**Subject: MHI's Responses to US-APWR DCD RAI No. 81-1253 Revision 0**

Responses to Request for Additional Information  
No.81-1253 Revision 0

**US-APWR Design Certification**

**RAI NO.:** NO.81-1253 REVISION 0  
**SRP SECTION:** 19 – Probabilistic Risk Assessment and Severe Accident Evaluation  
**APPLICATION SECTION:** 19.1  
**DATE OF RAI ISSUE:** 10/7/2008

Figure 19-121.1 High Head Injection System Simplified System Diagram

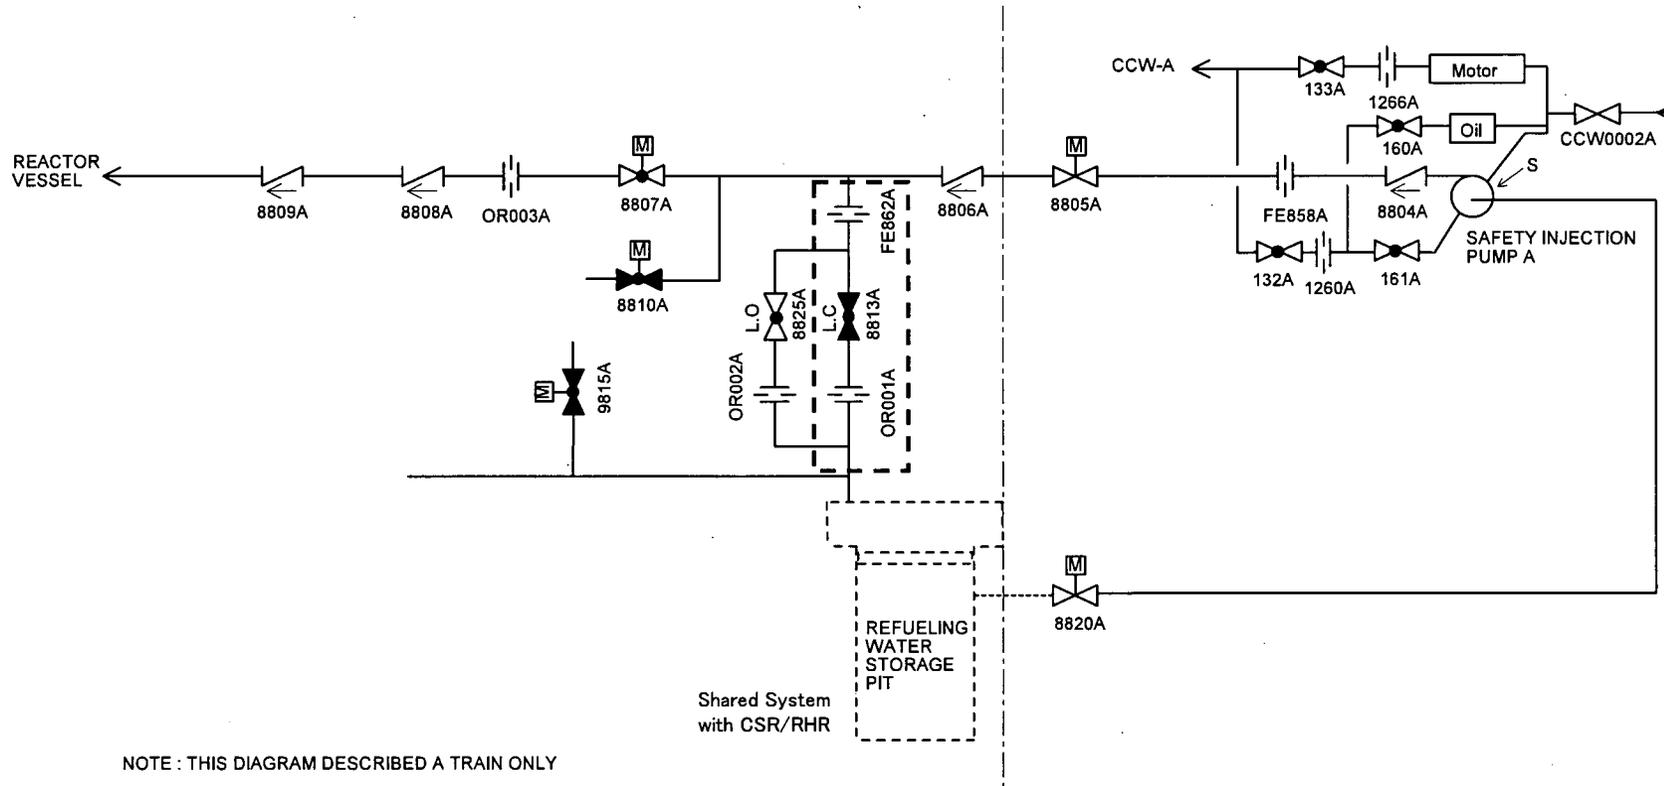
The event HPIPNELTSTCA (Table 6A.1-7) is described as "Piping non-service water system external leak L close side." Please clarify this description and explain what is meant by "non-service water system" (both in general terms and as it relates to the high head injection system (HHIS)).

The term "non-service water system" is used to indicate a system that is not the essential service water system. NUREG/CR-6928 "Industry-Average Performance for Components and Initiating Events at U.S. Commercial Nuclear Power Plants" provides two types of pipe failure rates, failure rates for the emergency service water (ESW) system and for non-ESW systems. Basic event HPIPNELTSTCA represents failure of piping in HHIS and the failure rate for non-ESW is applied to this event.

Basic Events HPIPNELTSTCA, B,C,D represent external leak event for the piping boxed in the bold dashed line in Figure 19-121.1. The values used to estimate the probability of the event are shown in Figure 19-121.1.
